Fingal Landfill Project Review of Environmental Impact Statement

7th September 2006

Fingal Landfill Project

Review of Environmental Impact Statement

Figure 1. Thickness of clay overburden (m)

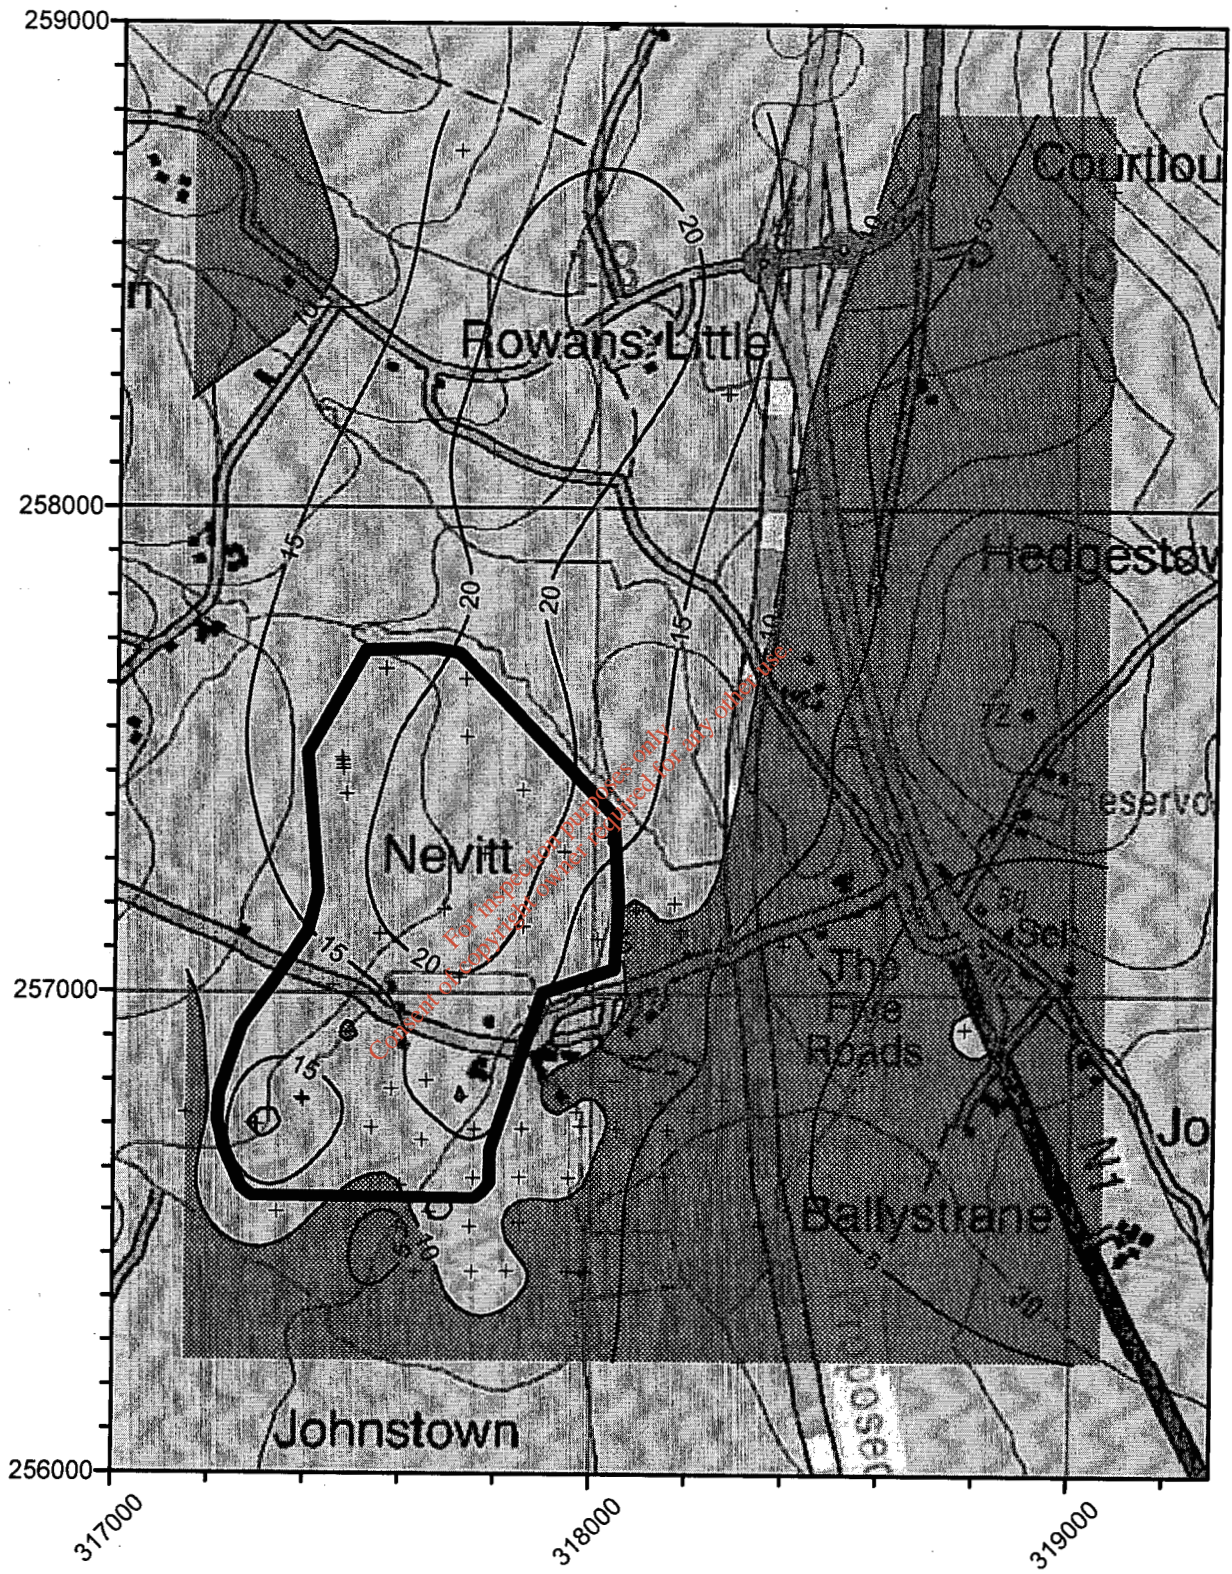
Figure 1 is a map of the present thickness of clay subsoil across the site, showing the watercourses and borehole locations. There is scope for uncertainty and interpretation in what constitutes "clay thickness" as, in some boreholes, the clay is not a continuous uniform sequence, but contains sand and gravel, or is described as "sandy, gravelly clay" or similar. Nevertheless, this map provides an indication of how close the landfill is to falling into the 'Moderate' Vulnerability classification.

- The EIS has not estimated the thickness of the clay till beneath streams.
- The EIS has not shown a map of thickness of the clay till beneath the proposed base of the landfill.
- It ignores the evidence for actual groundwater flow through the clayey overburden.

The failure to take these steps means that the aquifer at the site cannot readily be classified as 'Low' rather than 'Moderate' Vulnerability.
